Design Review Report

St Peter's Square, Ruthin

DCFW Ref: N340

Meeting of 16th July 2025

Current layout plan

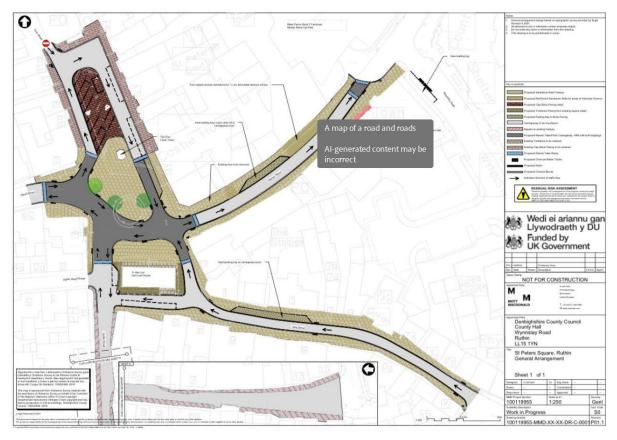
We understand some of the rationale behind the materials selection informed by some preliminary work, however a robust sequential approach, informing responses to context in terms of materials selection and local supply chain opportunities, was not evident in the proposals. Four different surface materials are at present undermining visual coherence of the space particularly around the Market Hall and informal crossing points and the use of

textured paving. Whilst there is a regulatory context, a better design solution should be sought.

Traffic and parking management is, we understand, to be managed by a mix of controls and planting, with cycle and motorcycle parking spaces provided, though these were not evident on the drawings received. It is therefore unclear what is and is not to be delivered and what opportunities are available to avoid restricting future opportunities for change and improvement over the long term.

The dialogue explored further detailed aspects in terms of the need to simplify materials, reduce clutter to an absolute minimum, consider lighting design carefully and build in flexibility to anticipate change. Road markings, not evident on the drawings, will likely be used and clarity about where and how is essential. Infrastructure for EV charging as well as event power were also explored. Building in flexibility for the current and future uses are important as parking and vehicle management will change over time, as will uses.

Active travel proposals, currently showing a cycle route to Market Street, do not clearly show delineation or resolve how cyclists are directed at the top and bottom of the street, raising useability and safety concerns. Whilst specialist advice has been taken there remains an opportunity to improve design solutions beyond current proposals. The drawings provided to the Commission do not show either clarity of approach or an adequate solution. Alternatives should be sought.

Microclimate analysis is not evident in materials and the decision not to include trees at the centre of the square has a bearing on managing climate, and opportunities for shade and street cooling, as well as water management and any SuDS requirements. Whilst historical reference is important, climate and environmental changes require that opportunities for substantial greening should be further explored.
